**BUSHEHR PETROCHEMICAL COMPANY  
MEG PLANT**

**HAZOP REPORT**

**BUPC MEG Plant HAZOP & SIL Report –  
N2 and Air Compressor  
Detailed Design**

**Client Report No: BUPC-17811-OO-0703**

DRAWING TITLE: 17811-03 P&ID FOR INSTRUMENT AIR COMPRESSOR

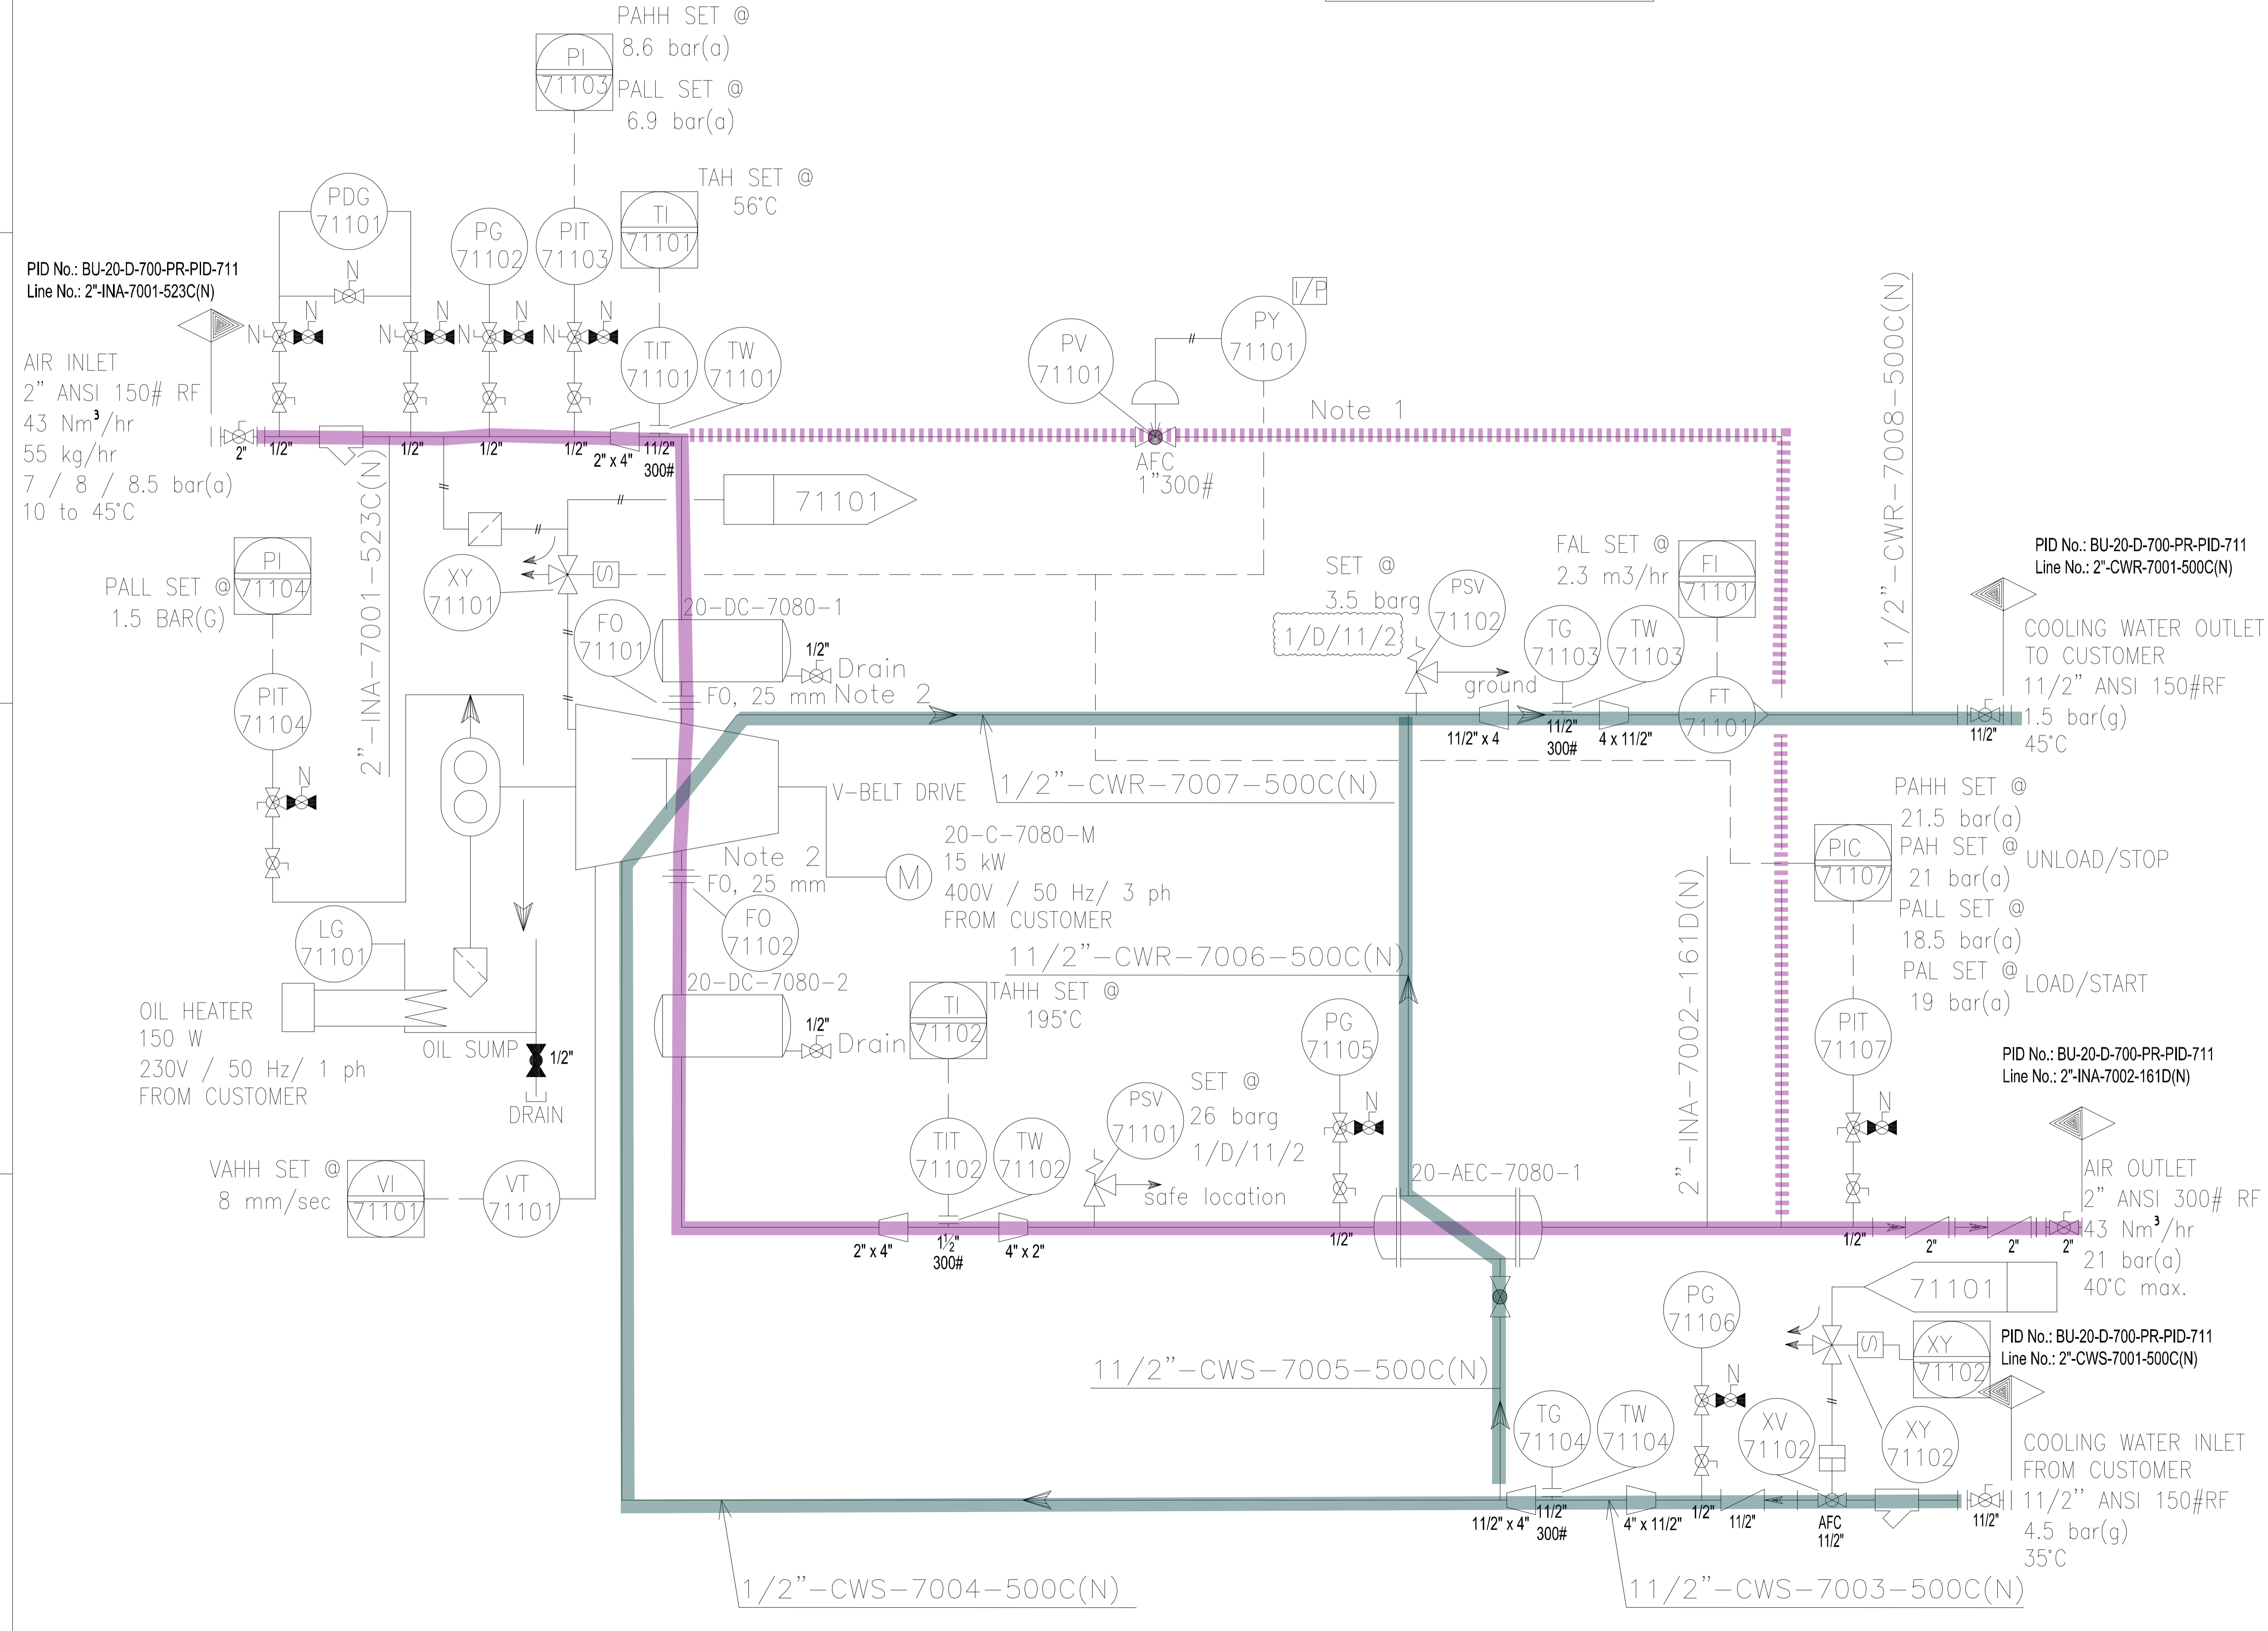
Node 3: Instrument Air

Node 4: Cooling Water AIR (IA) Compressor

03.1.1.1	Flow	No / Not	No/Less Flow	No Air supply from Plant	1. No Supply to the compressor leading to underpressure at the suction side of the compressor. Worst case is if recycle line is closed. No vacuum is expected, however the discharge pressure will decrease. Increase of temperature of the first stage exceeding the design temperature of the Compressor. Less supply to the end users. Vibrations of the axis of the compressor is possible. No loss of containment. No hazardous consequence. Asset damage (L) < 5000 US\$.	L	1. PIT-71103-PALL to Trip 20-C-7080 (UCP ESD) 1. PIT-71107-PALL to Trip 20-C-7080 (UCP ESD) 3. TIT-71102-TAHH to trip 20-C-7080 (UCP ESD)	1	3	SIL 0	1. PIT-71103-PALL to Trip 20-C-7080 (UCP ESD) 1. PIT-71107-PALL to Trip 20-C-7080 (UCP ESD) 3. TIT-71102-TAHH to trip 20-C-7080 (UCP ESD)	3	No action

03.2.1.1	Flow	More	More/High Flow	More flow over the recycle line by 'Fail Opened AFC PV-71101 or control failure to opened valve in case AFC should be NOT fully opened.	1. Decreased pressure and temperature in the second stage of the compressor. Less supply to the plant/ end user. No hazardous consequence; No asset consequence.		1. PIT-71107-PALL to trip 20-C-7080 (UCP ESD)
